HISTORIC PRESERVATION COMMISSION STAFF REPORT

Address:	217 Park Ave., Takoma Park	Meeting Date:	8/15/2018
Resource:	Outstanding Resource Takoma Park Historic District	Report Date:	8/8/2018
Review:	HAWP	Public Notice:	8/1/2018
Case Number:	37/03-18EEE	Tax Credit:	n/a
Applicant:	Daniel Mudd	Staff:	Michael Kyne
Proposal:	Pergola construction and wheelchair ramp relocation

PERRY-MUDD RESIDENCE

217 PARK AVE
TAKOMA PARK, MD 20912

Figure 1: 217 Park Ave.

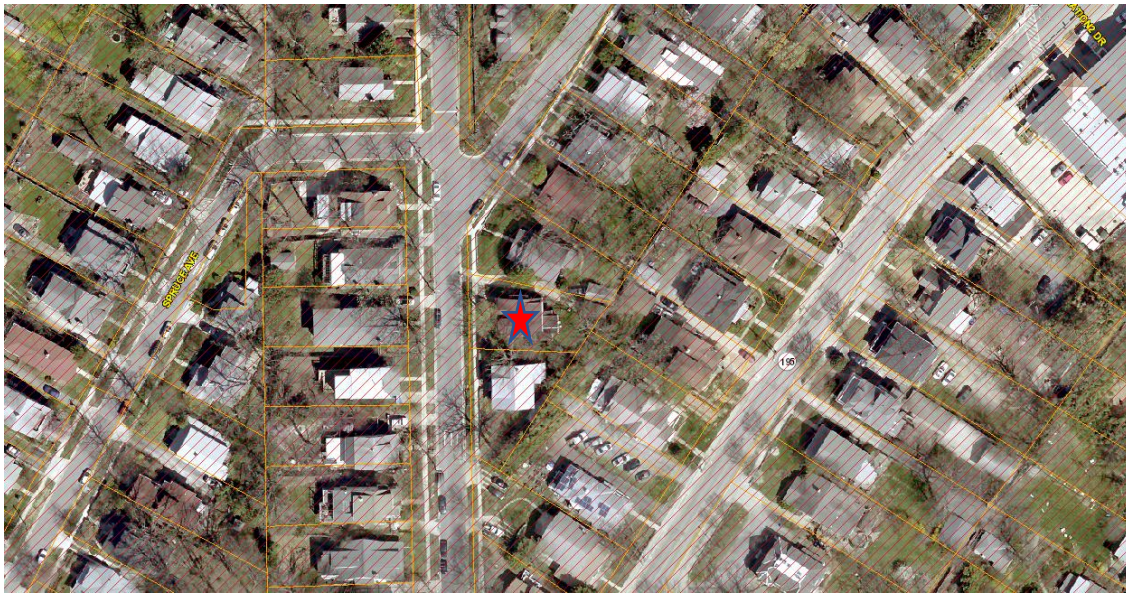
Staff supports the applicant’s proposal, finding that the proposed work items are generally compatible with the character of the historic house. The proposed alterations will be far removed from the street at the rear of a non-historic rear addition, where they will not detract from the character-defining features of the historic house, in accordance with *Standards #2* and *#9*.

Staff recommends that the Commission **approve** the HAWP application under the Criteria for Issuance in Chapter 24A-8(b), having found that the proposal is consistent with the *Takoma Park Historic District Guidelines* identified above, and therefore will not substantially alter the exterior features of the historic

SITE PLAN - INCLUDING PERGOLA
 1 in = 20 ft

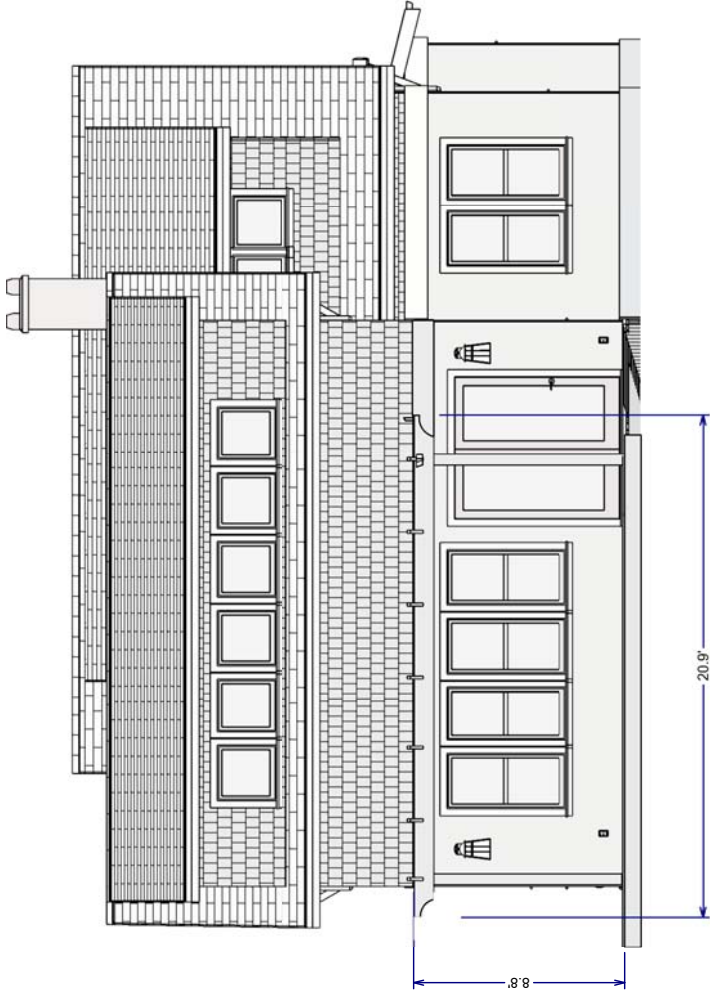
A 20.9’ wide x 12.4’ deep cedar pergola is proposed at the rear of the previously approved rear addition. The pergola will include two posts at the rear and three ceiling fans.

The previously approved wheelchair ramp at the rear of the previously approved rear addition and deck is proposed to be relocated to the north (left) side of the deck. The ramp will be constructed from cedar and the height will not exceed 18”. The ramp will be side loaded from the driveway at the north (left) side of the house and will include one 3’ x 3’ landing and a simple pipe handrail.
